ISSUE: Certificate of Appropriateness for new construction

APPLICANT: City of Alexandria and Washington Metropolitan Area Transit Authority (WMATA)

BAR#2019-00241
2901 Potomac Ave. (2405, 2501, and 3701 Potomac Ave., 3251 Potomac Ave.
[Parcel ID 016.04-01-01], 700 Carpenter Rd, 1702 & 1880 Potomac Greens Dr.)

**Contract No. FQ16146 - Washington Metropolitan Area Transit Authority
(WMATA) Potomac Yards Metrorail Station
LTR-0104-PM-City of Alexandria January 22nd, 2020 BAR Submission**

WMATA POTOMAC YARD METRORAIL STATION
 ARCHITECTURAL
 BAR SUBMISSION
 DOWNSPOUT OVERALL DIAGRAM

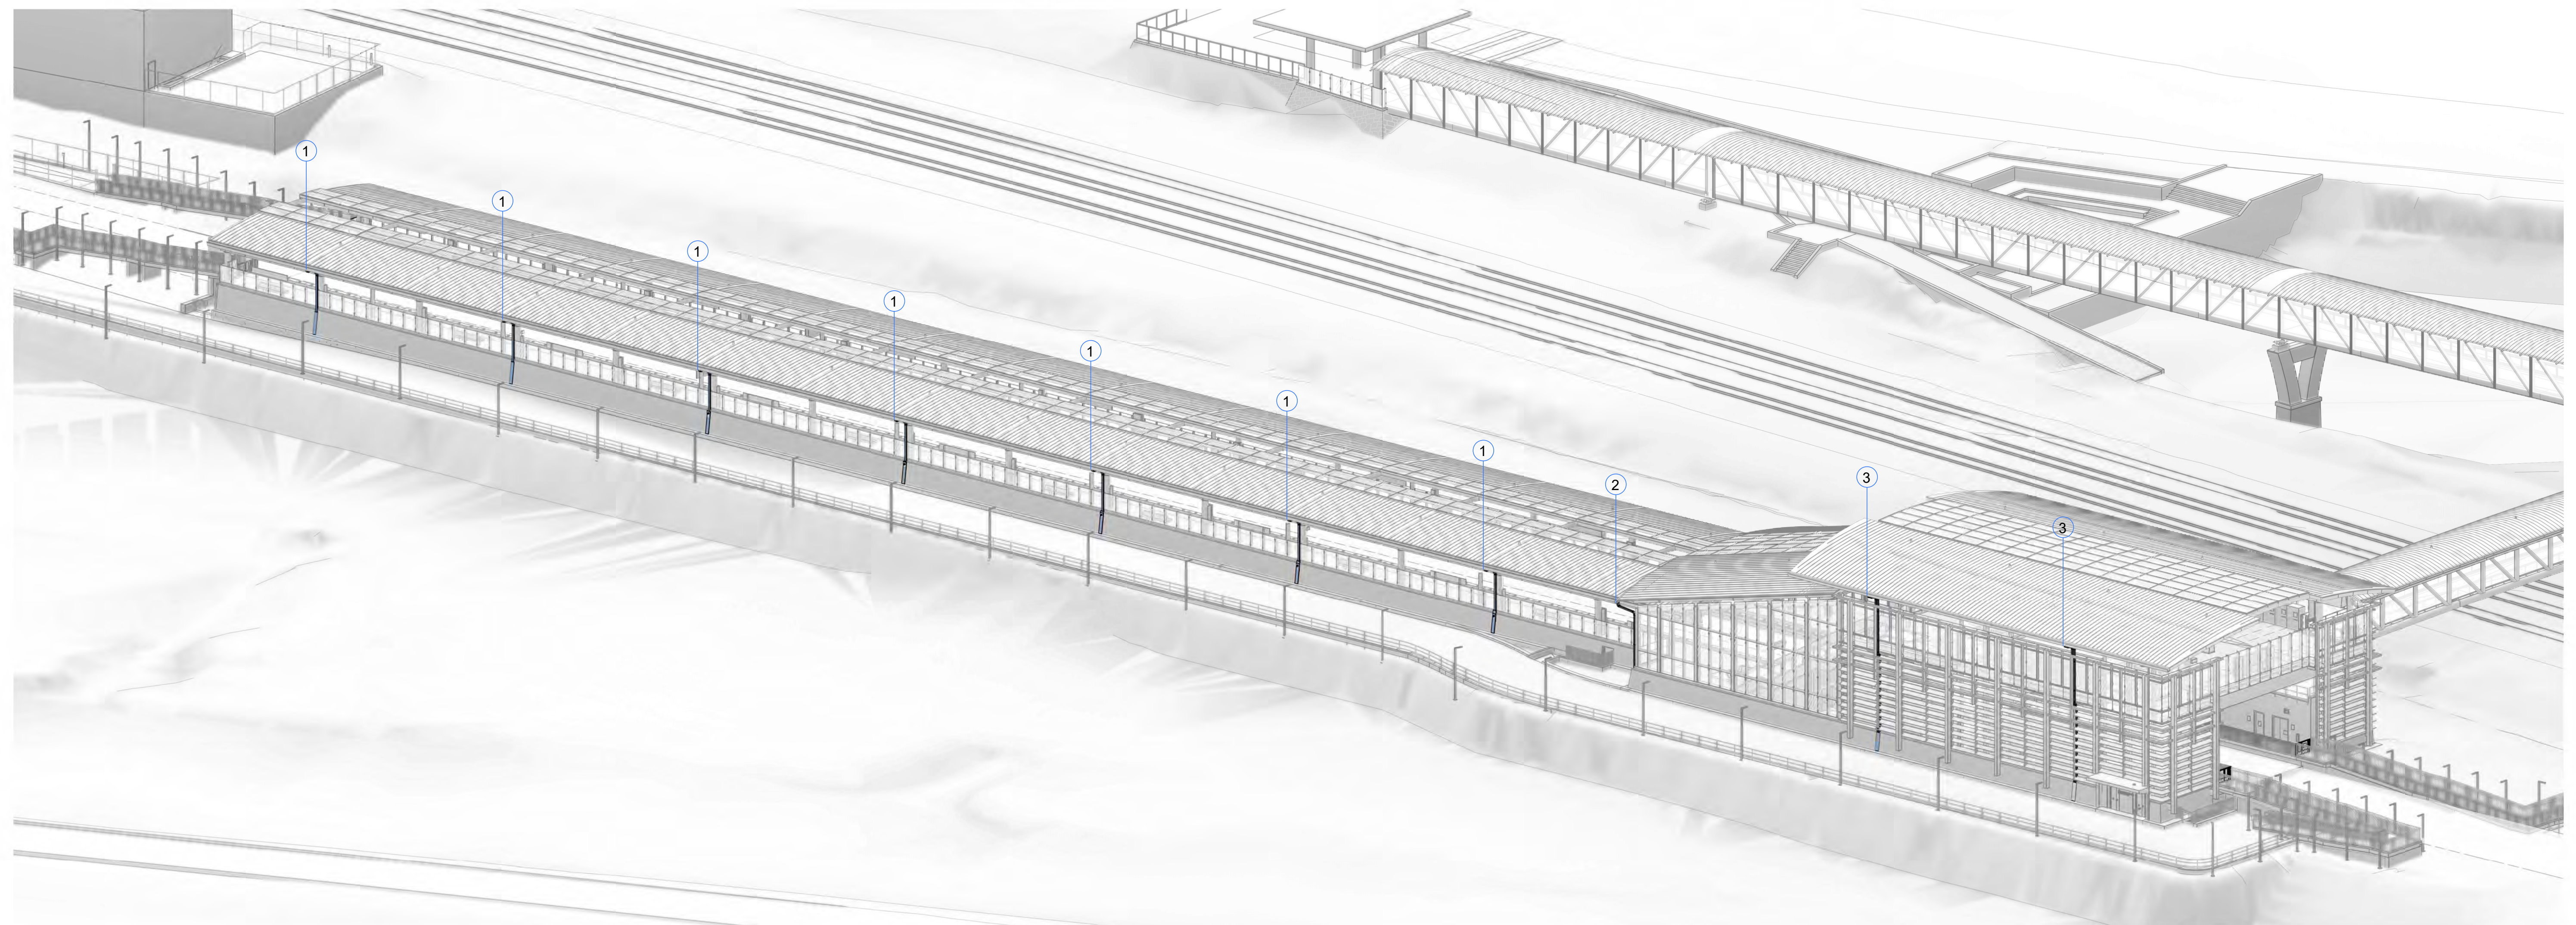
At the previous meeting, the BAR approved the downspout locations on the mezzanine and platform of the station, as submitted, with the applicant to return with additional details of the combined conductor head, a restudy of square or rectangular downspouts in lieu of round and with additional details of the metal cover plate at the notch in the stone base of the building.

The conductor head has been combined into a single, custom made leader from the bottom of the gutter to the downspout, which will be held as tightly as possible to the angled truss member. The 4” x 6” downspouts are all fabricated of heavy gauge rectangular aluminum. The joints and connections have been shown at the transitions, though their prominence is somewhat exaggerated in the renderings and they likely will not appear as bold in the field. Staff has been assured that the support straps will be visually minimal and will have blind fasteners to the structures.

1. Approval of the downspout details with the color of the downspouts to match the adjacent structural feature and final review of the cover plate details by staff; the Chocolate Brown Met color flat exoskeleton finish; and the guardrail and stone retaining wall, as submitted.
2. Deferral of the cast stone details and west elevation of the entrance pavilion on the west side of the tracks, the glass handrail/guardrail details in the station and exoskeleton connection details.
